Comparison:

4GNxxxK

4GNxxxS

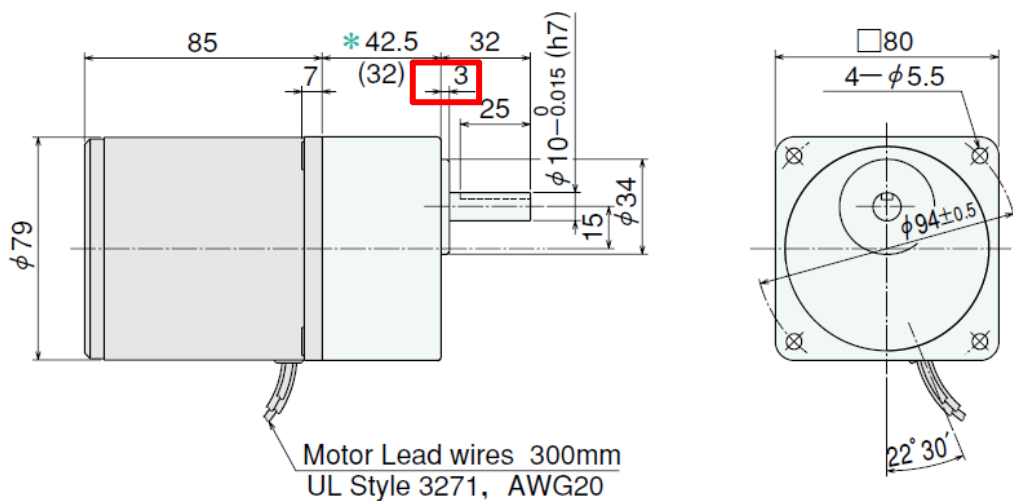
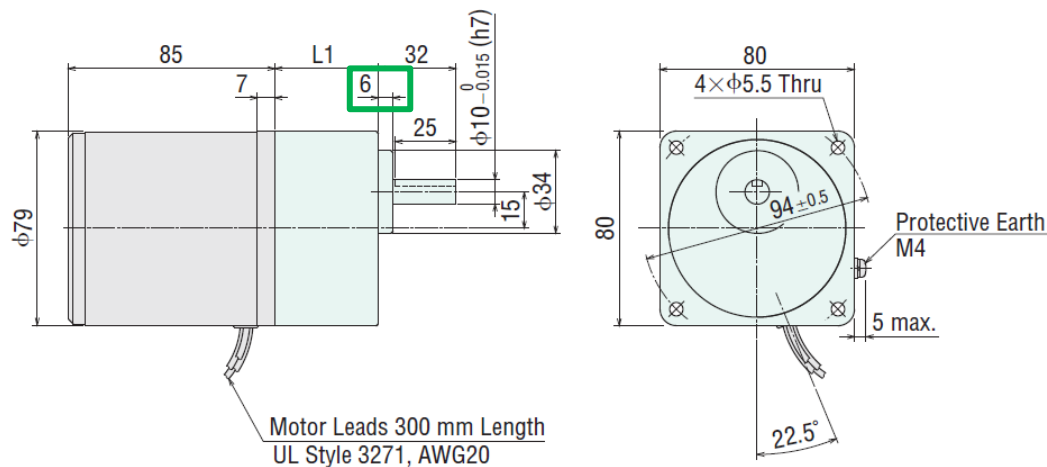
Asterisk (*) indicates dimensions of **4GN25K ~ 180K**,
the figure in parenthesis indicates dimensions of **4GN3K ~ 18K**.

Motor Model	Gearhead Model	Gear Ratio	L1
4IK25GN-CW2E	4GN□S	3~18	32
4IK25GN-SW2		25~180	42.5
